SHREWSBURY MIDDLE SCHOOL  
Sherwood Avenue  
Shrewsbury, MA 01545

PROJECT: TOWN OF SHREWSBURY ACCESSIBILITY PROJECT  
SHREWSBURY MIDDLE SCHOOL  
DRAWING: FLOOR PLAN  
SCALE: 1/32" = 1'-0"  
DATE: FEBRUARY, 2002

**Toilet T-9**

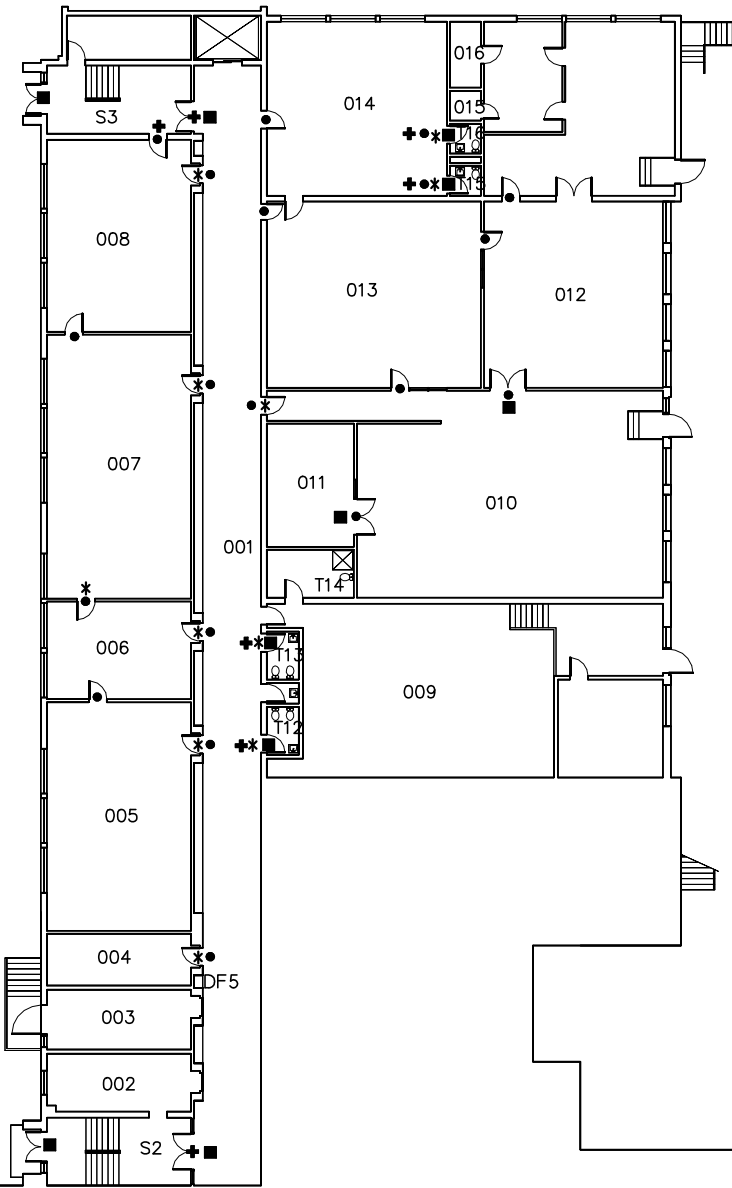
<i>Item</i>	<i>Action Required</i>	<i>Est. Cost</i>	<i>Priority</i>	<i>Feasibility</i>
<b>Toilets T-1, T-2, T-3, T-6, T-11, T-12, T-13, T-14, T-15, T-16, T-20 and T-21.</b>				
No sign pointing to nearest accessible toilet rooms.	Add signs	1,200	3	1
<b>Toilets T-4 and T-5</b>				
No accessible sign	Add signs	200	2	1
Toilet not 18" from wall	Relocate toilets in accessible stall	6,000	3	3
Urinals too high	Lower one urinal.	1,000	3	3
Lock in stall at the incorrect height	Correct lock height.	500	3	2
<b>Toilets T-7 and T-8</b>				
Both toilet rooms fail in all required clearances, fixtures and accessories.	We recommend that both rooms be enlarged to provide fully accessible toilet rooms for adults.	60,000	2	3

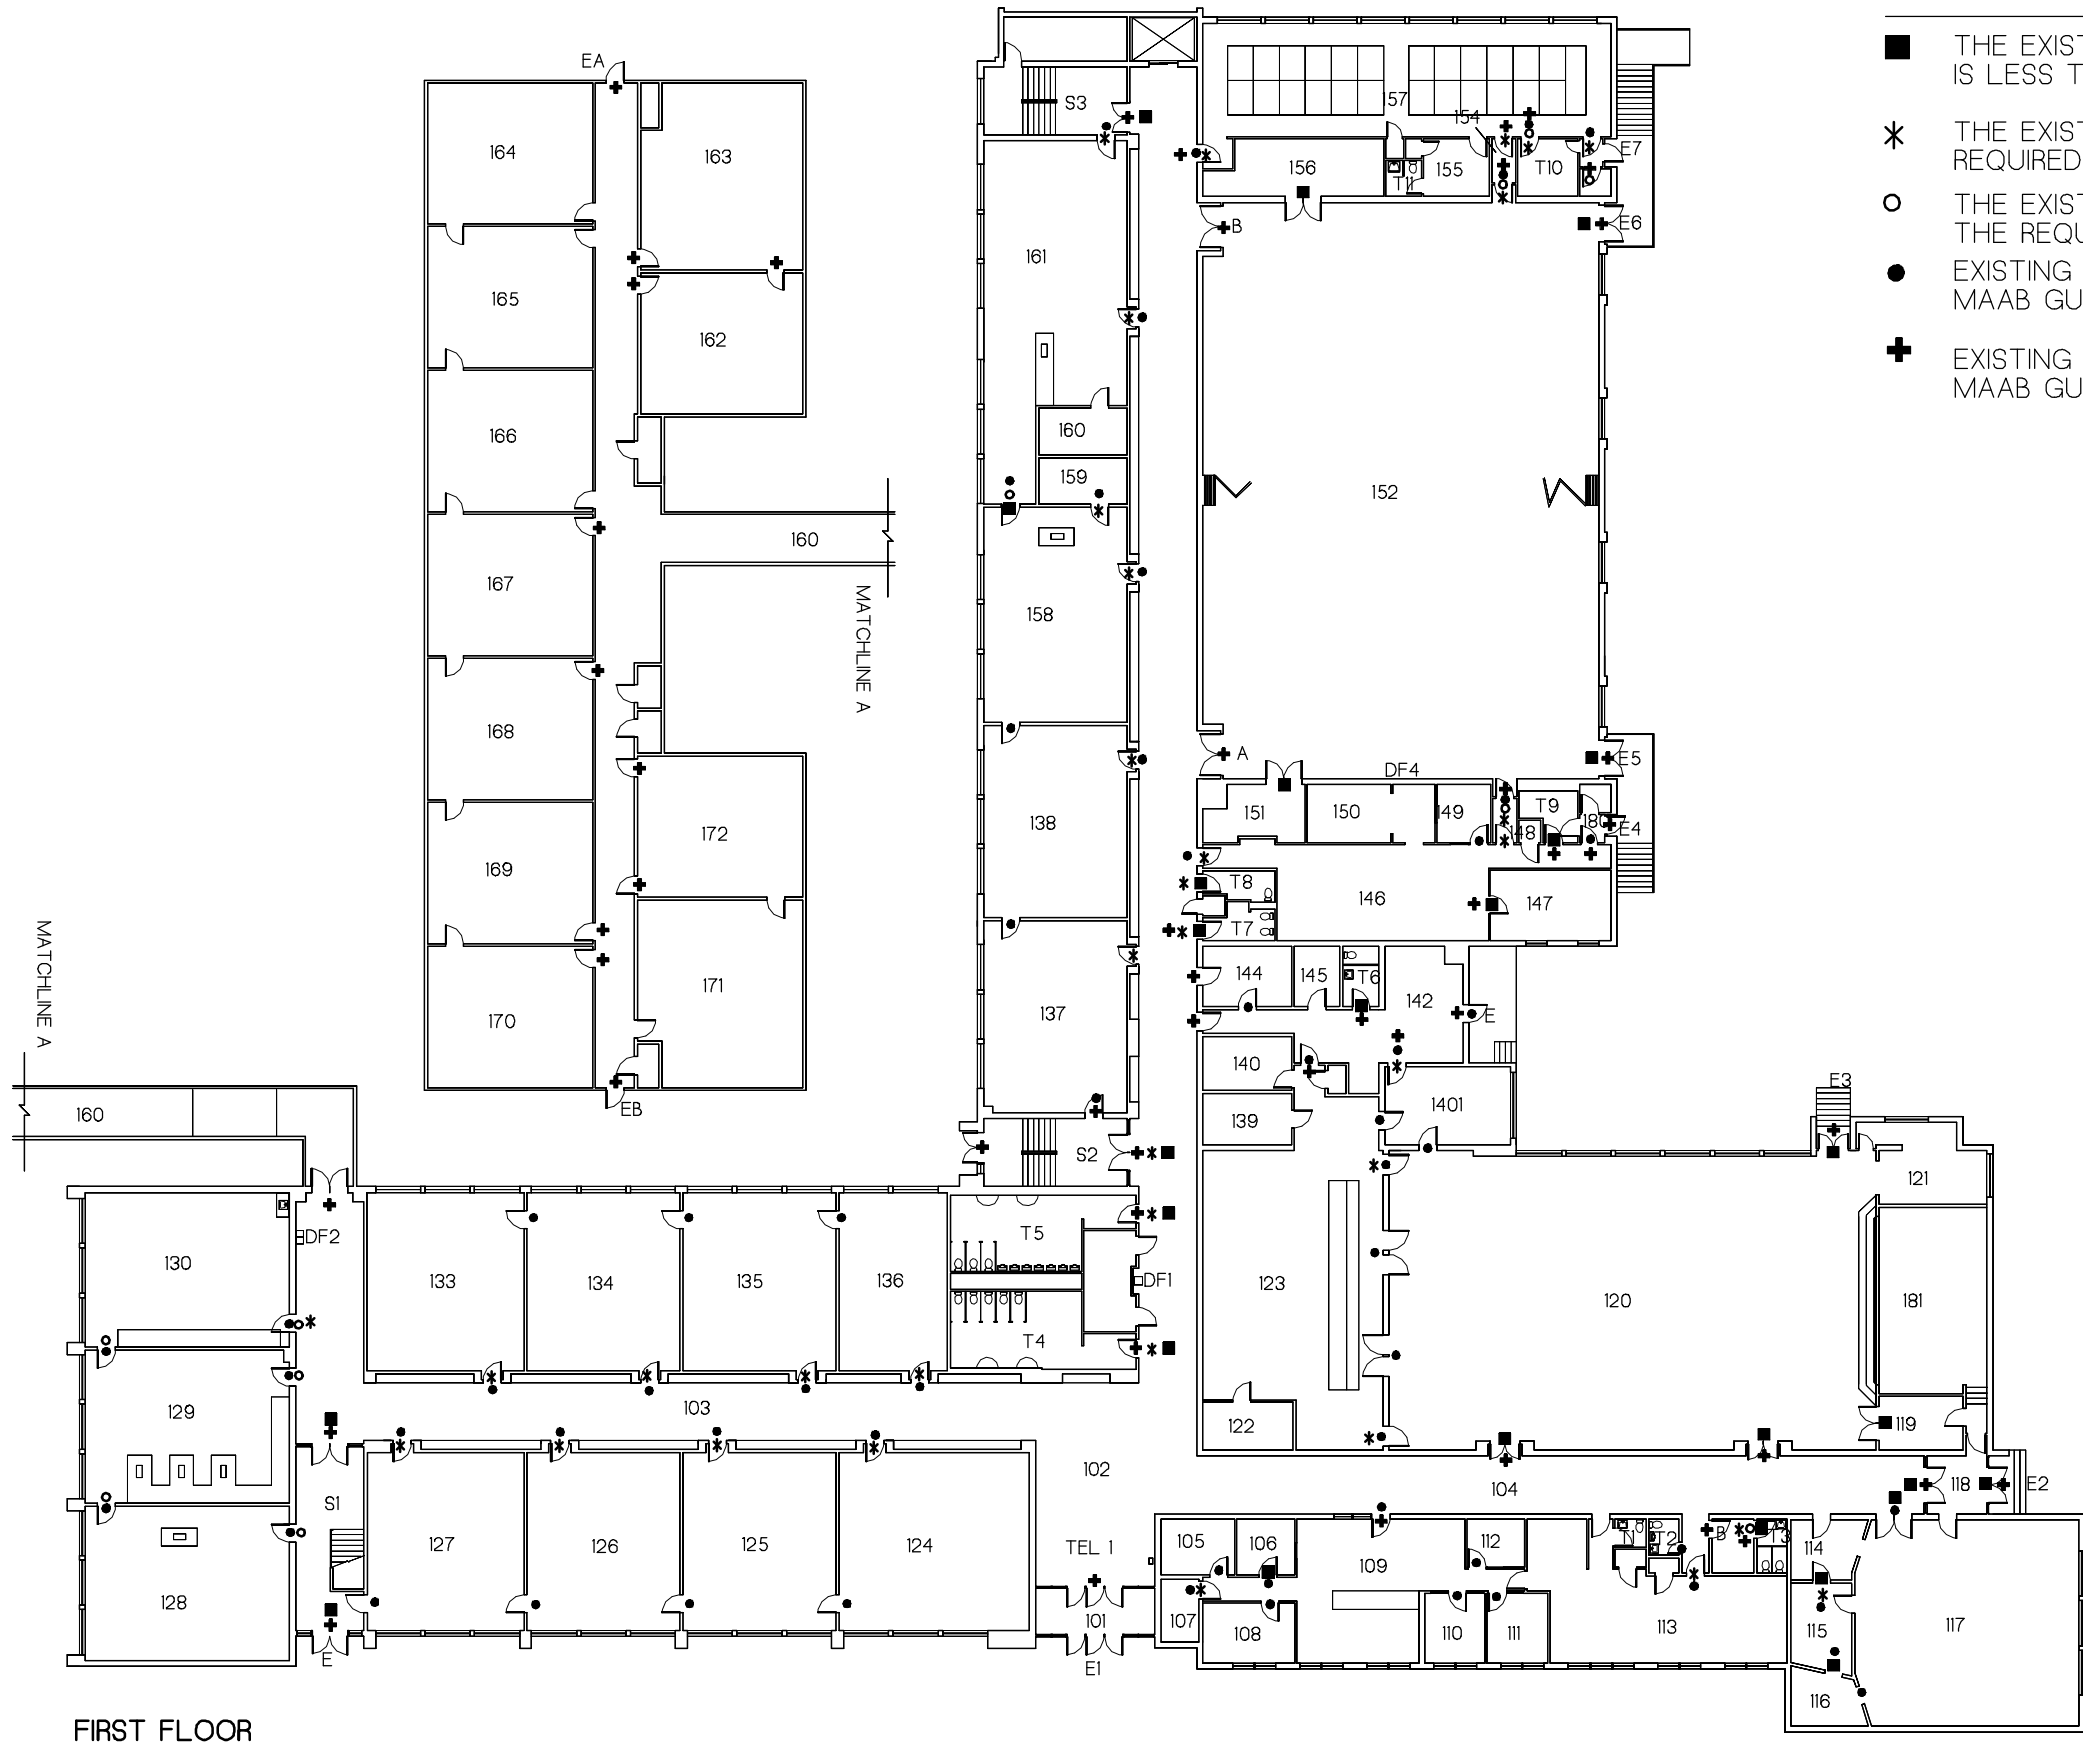
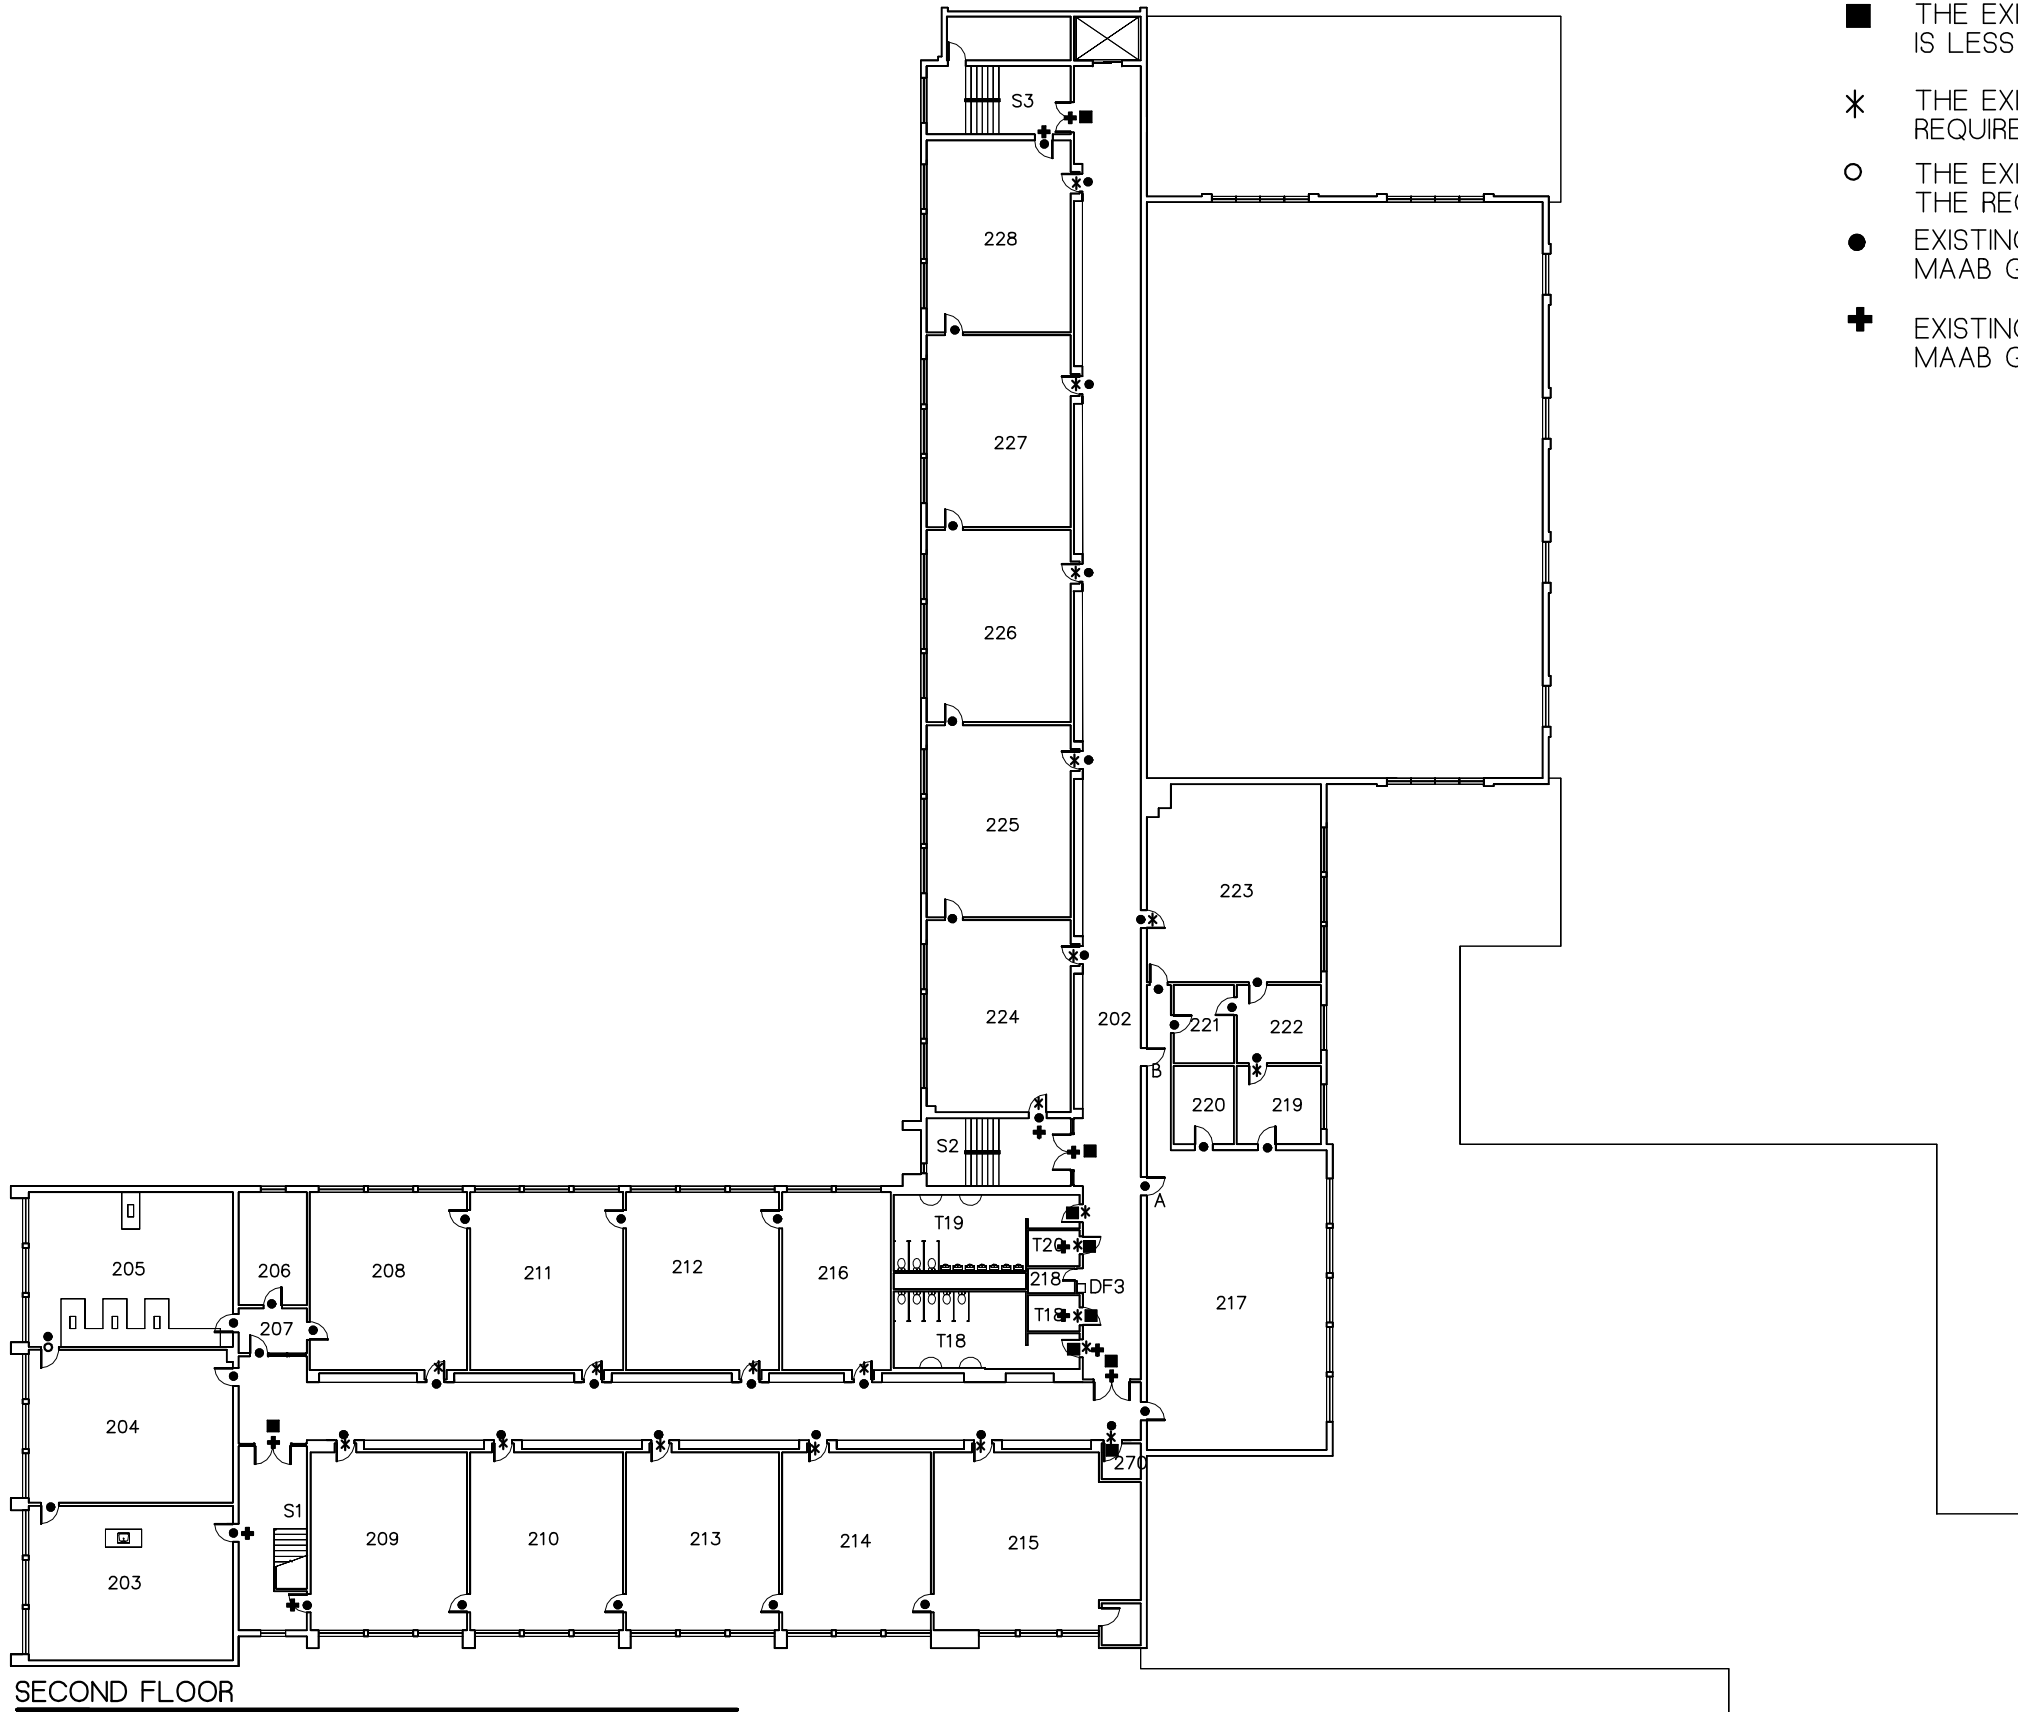
<i>Item</i>	<i>Action Required</i>	<i>Est. Cost</i>	<i>Priority</i>	<i>Feasibility</i>
11 doors do not have the required 32" clearance.	Correct doors T4, T5, T7 and T8 providing access to accessible toilet rooms. All other non-conforming doors lead to non-accessible spaces or can be reached via alternate routes.	16,000	2	3
58 doors do not have the required clearance from pul side	Doors listed above are included in the above noted costs and action. All classroom doors (32) although difficult, should be reconfigured. All other doors lead to non-accessible spaces or is extremely difficult to accomplish.	102,000	2	3
8 doors do not have the required clearance on the push side.	We recommend correcting doors leading into labs 129, 129 and 130. All other doors lead to non-accessible spaces or can be reached via alternate routes.	9,000	2	3
120 doors have knob type hardware.	Replace with lever hardware.	48,000	2	2

50 doors have closers that close too fast or hare too hard to operate.	Replace or adjust closers.	25,000	2	2
